STAFF COMMENTS

August 20th, 2015

SUBJECT: **Case # 4195:** Special Permit located at 273 Cleveland Street (Map 12, Lot 110)
Case # 4196: Variance located at 273 Cleveland Street (Map 12, Lot 110)

**Planning staff notes on
plan submitted**

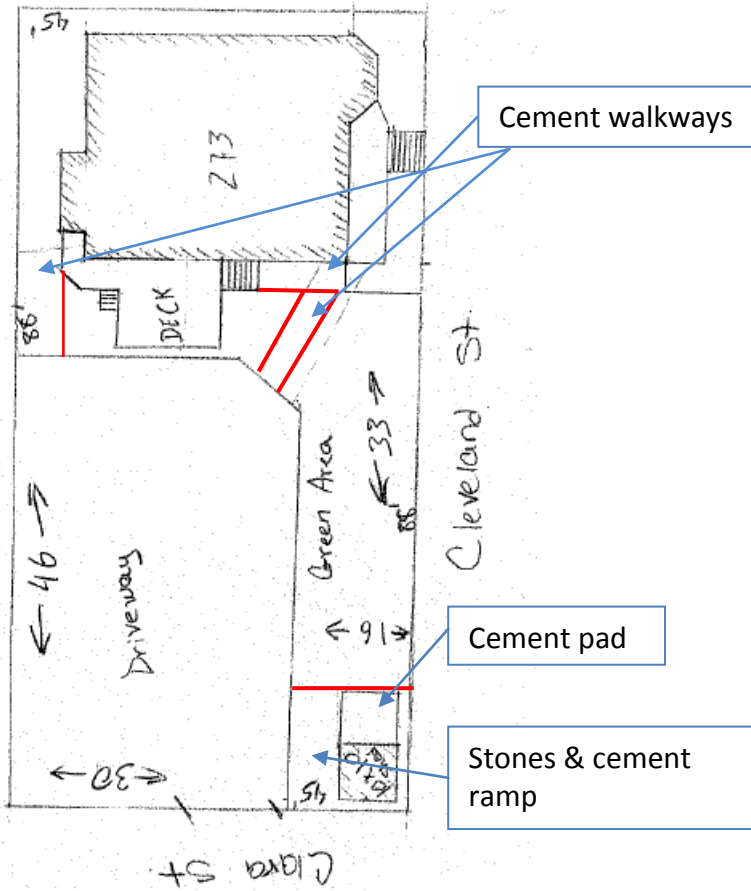
In light of our review of the entire petition, accompanying materials, and a visit to the site, staff would characterize this proposed driveway in character with the surrounding neighborhood. The driveway provides off-street parking that did not previously exist at the site. However, staff would characterize the driveway as unnecessarily large for a single family home— five average car parking stalls (9'x18') could easily fit based on the dimensions of the driveway.

Therefore, in regards to the variance for green space, staff questions the need for the approximately 15'x10' cement pad for the 10'x10' shed. Also, staff noted the space in front of the shed is filled with loose stone. Staff would suggest the applicant reduce the size of the cement pad, replace the loose stone with grass or natural plantings to regain the necessary percentage of green space for the property. Additionally or alternatively, staff suggests the applicant remove a minimum 4'x 46' foot area of the driveway to provide a 4' setback from the rear abutting neighbor's property line. Additionally the applicant should install curbing along the west side, in order to protect the adjacent dwelling.
